Revision to a Request for a Standing Offer

Title - Sujet PACKAGING MATERIALS	
Solicitation No. - N° de l'invitation W8486-138388/C	Date 2014-07-21
Client Reference No. - N° de référence du client W8486-138388	Amendment No. - N° modif. 001
File No. - N° de dossier hs634.W8486-138388	CCC No./N° CCC - FMS No./N° VME
GETS Reference No. - N° de référence de SEAG PW-\$SHS-634-65321	
Date of Original Request for Standing Offer 2014-07-03	
Date de la demande de l'offre à commandes originale	
Solicitation Closes - L'invitation prend fin at - à 02:00 PM on - le 2014-07-31	
Time Zone Fuseau horaire Eastern Daylight Saving Time EDT	
Address Enquiries to: - Adresser toutes questions à: Paquin, Benoit	Buyer Id - Id de l'acheteur hs634
Telephone No. - N° de téléphone (819) 956-3966 ()	FAX No. - N° de FAX (819) 956-5227
Delivery Required - Livraison exigée	
Destination - of Goods, Services, and Construction: Destination - des biens, services et construction:

Amendment 001 is raised to provide a supplier's questions and Technical authority answers.

Subject: Questions and Answers

Double Wall Corrugated Sheet

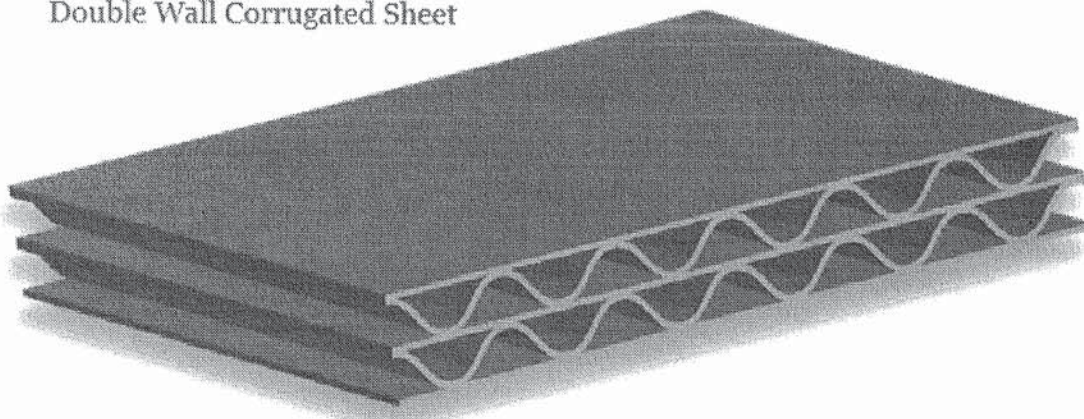
-
- 4) **Rifle Box:** Specs read for B Flute and Double Wall, B Flute is not double wall corrugated, please advise. Specs mention immersion test, a carton box will not pass full immersion test even if laminated, should this box be made out of Coroplast (plastic) or could we get specific on what immersion test is? Again, how many boxes should be packed per carton, only spec is 25 lbs max, is this only spec to be followed?

Part A (Flute and Double Wall)

It is possible to have B flutes and double wall. B flute specifies the dimensions of the flute and double wall the number of partitions (3). To be more specific, what we want is a B+B flute double wall corrugated cardboard box. Please see sketch below for a visual example.
